TITLE: HX711 Load Sensor		REV: 1.0
EasyEDA	Company: bauer.tech	Sheet: 1/4
	Date: 2020-08-10	Drawn By: Martin Bauer

TITLE: ESP32		REV: 1.0
EasyEDA	Company: bauer.tech	Sheet: 2/4
	Date: 2020-08-13	Drawn By: Martin Bauer

TITLE: High Voltage Step Down		REV: 1.0
EasyEDA	Company: bauer.tech	Sheet: 4/4
	Date: 2020-09-01	Drawn By: Martin Bauer

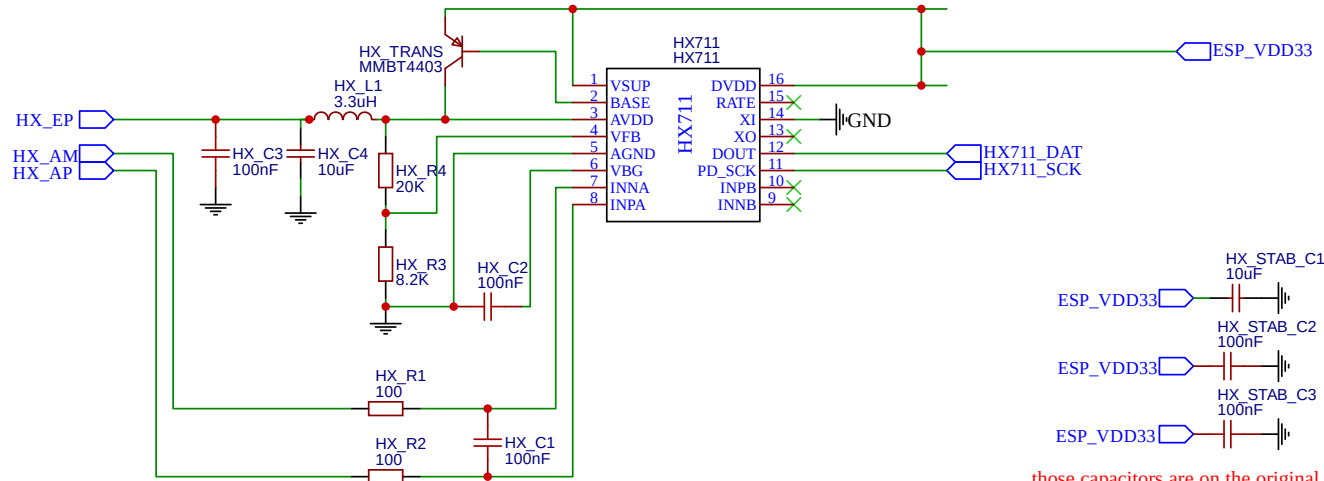
those capacitors are on the original sparkfun board
can I leave them out, since VDD33 should be stabilized already?

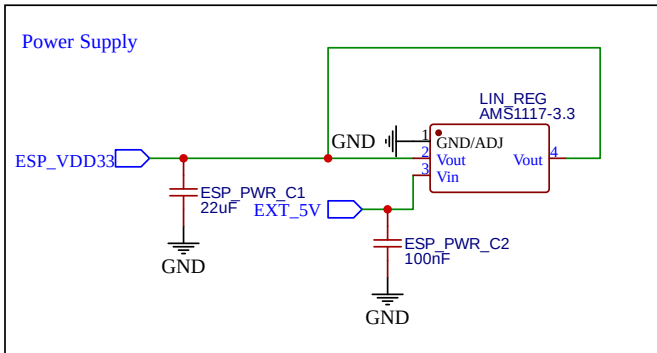
in the ESP32 data sheet there are 25V and 50V capacitors here, why? should be max 5V right? not too important, since I found cheap 25V and 50V versions

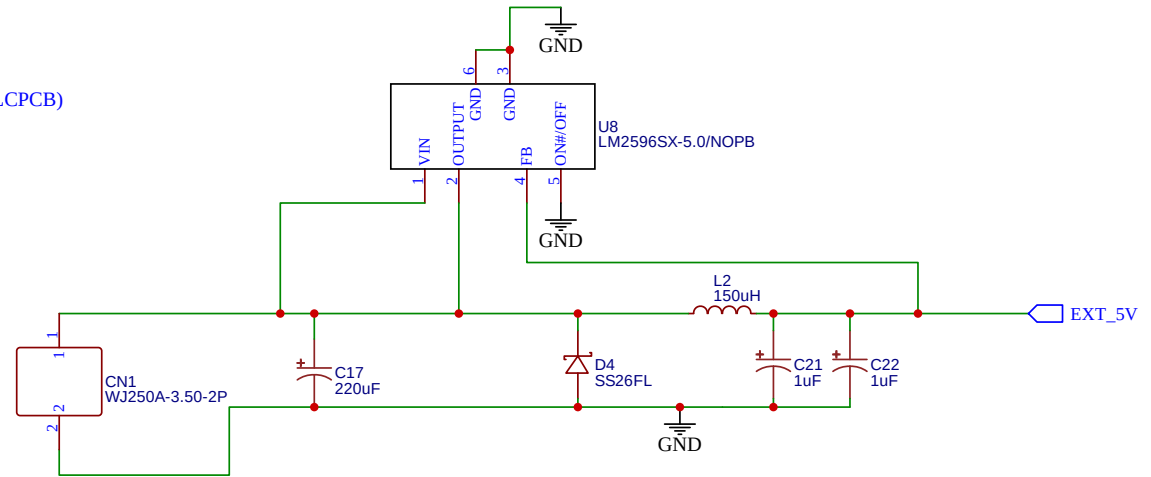
- Goal: power by typical outdoor power supply
- googled around and found Texas Instruments LM2596SX
- they have a tool to design circuit:
 - <https://webench.ti.com/power-designer>
- Selected Parameters
 - Input 12V - 25V
 - Output 5V at 0.8A
 - (0.8A because for higher currents I couldn't find the suggested components on JLCPCB)
 - Temp 30
- From the tool selected components that JLCPCB offers
 - Input Cin: UUD1H221MNL1GS (Nichicon)
 - Diode D1: SS26FL (Fairchild Semiconductors)
 - Inductor: SLF12575T-151M1R5-PF (TDK)
 - Outout Cout: 2x TPSA105K035R3000 (AVX)
- Open Questions
 - ESP32 datasheet mentions 0.5A, so 0.8A design should be enough?
